RE: **Juan Tabo Hills Estates**  
**Revised Grading Plan**  
**Engineer's Stamp Date: 8/9/18**  
**Hydrology File- M21D018; DRB# 1005278**

Based on the submittal received on 8/17/18, the revised grading plan cannot be approved until the following are corrected:

**Re: Juan Tabo Hills**  
**File: M21D018, DRB 1005278**

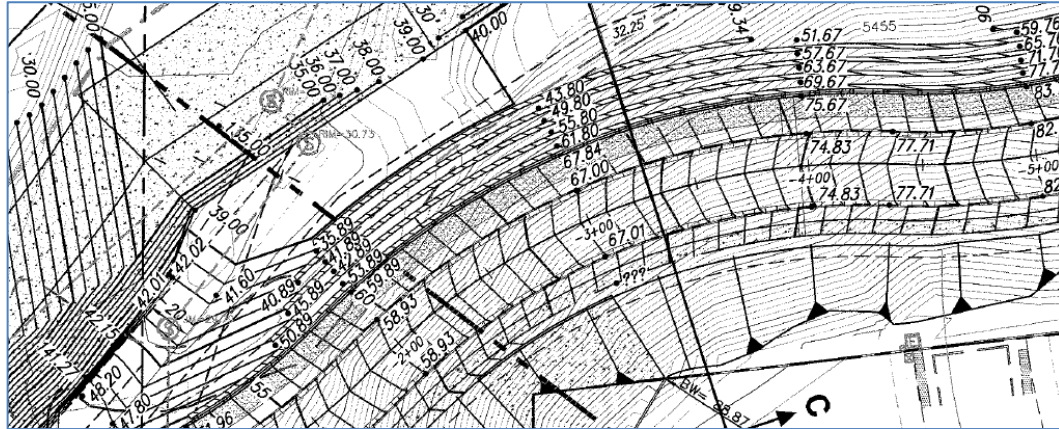
1. Fill in or provide an armored drainage conveyance for the low spot south of the Rocky Top entrance. This area cannot be allowed to pond adjacent to the road embankment:

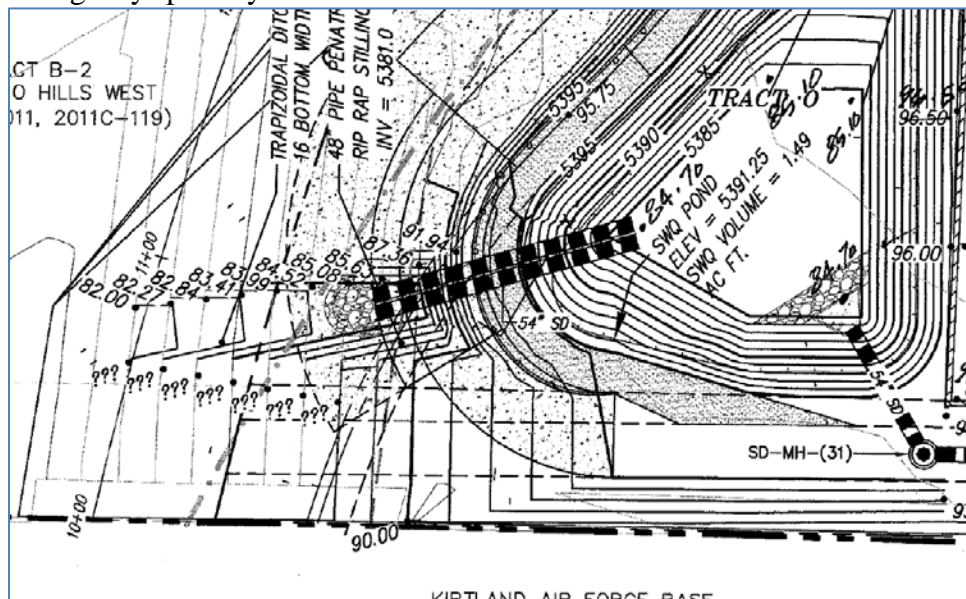
3. Provide self-ponding areas in the interspace (park) between the AMAFCA access road and the public road, or drain away from bank protection per AMAFCA direction. The contours and spot elevations should reflect the access road as sloping at 2% away from the top of shotcrete and back into the park area. If used, the ponding areas should be sized for the 10-day, 100-yr volume with supporting calculations provided.
